PLANNING, ZONING, & BUILDING DEPARTMENT  
PZ&B Staff Combination Memorandum: Architectural Commission and Town Council

SUBJECT: ARC-24-0061 (ZON-24-0038) 222 SEASPRAY AVE (COMBO)

MEETING: SEPTEMBER 25, 2024, ARCOM  
OCTOBER 09, 2024, TC

PROPOSED RENDERING OF REAR YARD WITH SECOND FLOOR ADDITION AND PERGOLA  
RTS

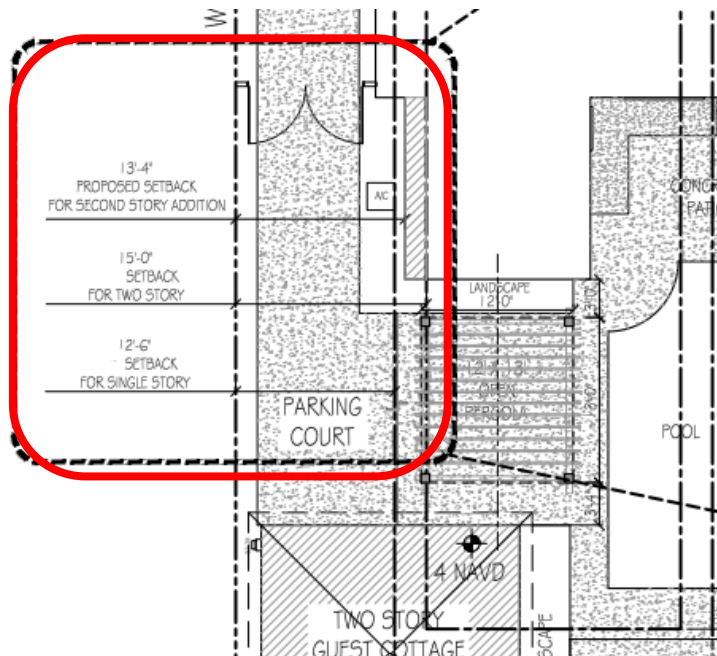
The applicant is proposing the construction of a second story addition over an existing one-story projection at the rear of the home. An open, freestanding, white aluminum 180 SF pergola is proposed between the main house and the accessory structure. New impact multilite sash windows are proposed as well as new multi lite doors. The 6/6 lite pattern is a vast improvement to the existing casement windows that are highly reflective and feature a single horizontal muntin to attempt a simulation of a sash product. Some plans also show the addition of a hip roof over the existing flat roofed two-story accessory structure. A preliminary review of the project indicates that the application, as proposed, is inconsistent with the Town zoning code and requires at least one (1) variance to achieve the application as proposed. The hip roof would also require a rear, side and building height variance for the accessory structure. Drainage concerns have been noted and the addition of the hip roof has not been sufficiently design detailed at this stage to proceed.

Additionally, the applicant has included plans indicating the addition of a hip roof to the accessory structure. However, appropriate variance requests to achieve this were not filed in a timely manner to accommodate this current application and would warrant future variance requests.

The design requires one variance as proposed to allow a second story rear addition of a bedroom to align with the positioning of the one-story rear projection of a kitchen which is 13'-4" away from the west property line versus the required 15'-0" for a second story.
